EAGLE MOUNTAIN CITY

City Council Staff Report

Project:	**Oquirrh Mountain Ranch Phase A – Preliminary Plat**
Applicant:	Oquirrh Mountain Ranch LLC (Agent – Ryan Kent)
Type of Action:	Action Item
Planning Commission:	Recommended Approval with Conditions (4-0, with 1 absent)

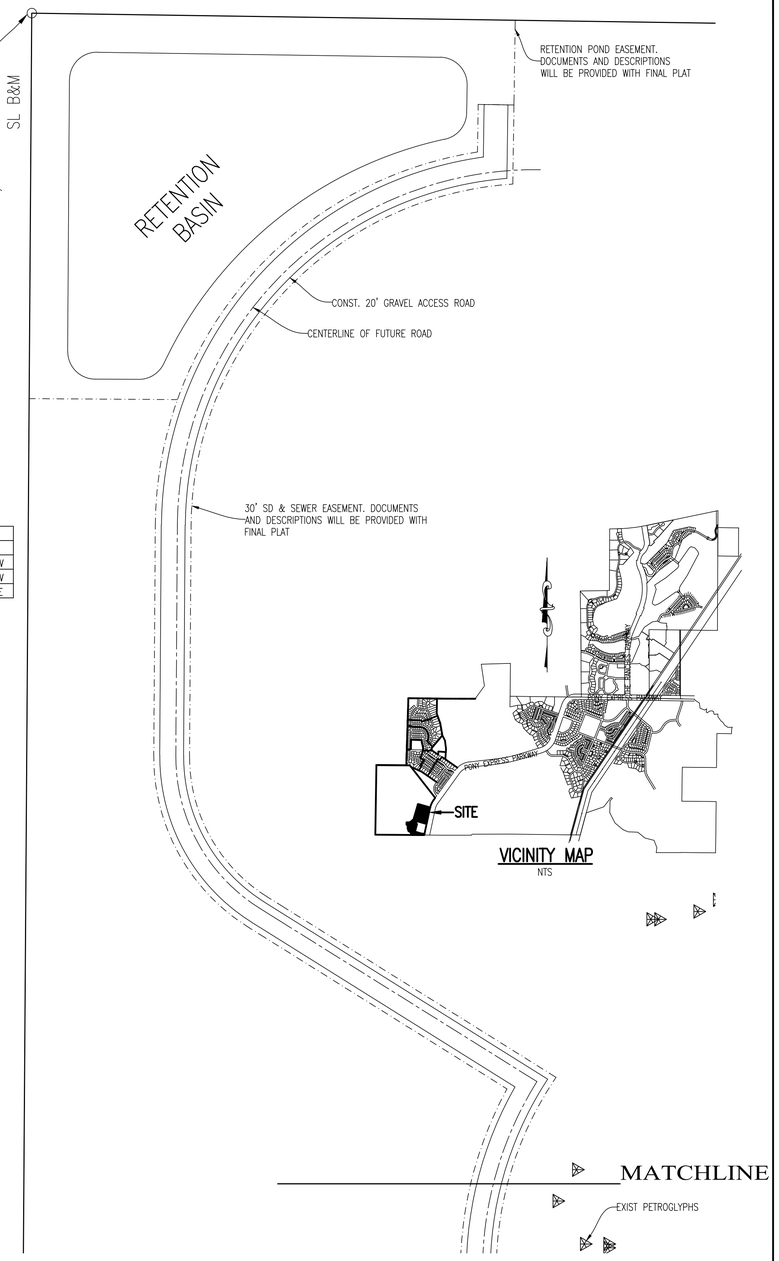
1. Provide bench drains and inlets to handle storm water runoff on hillside lots that meet City Engineer's approval.
2. The 20-foot building setback on the southern boundary is to include a 10-foot landscaped corridor on the applicant's plans and plats – to be one-half of a 20-foot corridor to be cooperatively planned with SITLA, which will provide both the other 10-foot landscaped portion of the corridor and the trail.

- Transitioning and Setback Requirements – The master development agreement requires a 20-foot setback along the southern boundary. Additionally, the 20-foot building setback is to include a 10-foot landscaped corridor on the applicant's plans and plats – to be one-half of a 20-foot corridor to be cooperatively planned with SITLA, which will provide both the other 10-foot landscaped portion of the corridor and the trail. At the Planning Commission meeting the applicant stated his intent to dedicate the 10-foot strip to the City. If this is the case, the plat must be revised to indicate this.

20' BUILDING SETBACK ALONG THE SOUTH BOUNDARY. SETBACK TO INCLUDE 10' LANDSCAPED CORRIDOR. THIS 10' CORRIDOR TO BE THE ONE-HALF OF A 20' CORRIDOR TO BE COOPERATIVELY PLANNED WITH SITLA, WHICH WILL PROVIDE BOTH THE OTHER 10' LANDSCAPED PORTION OF THE CORRIDOR AND THE TRAIL.
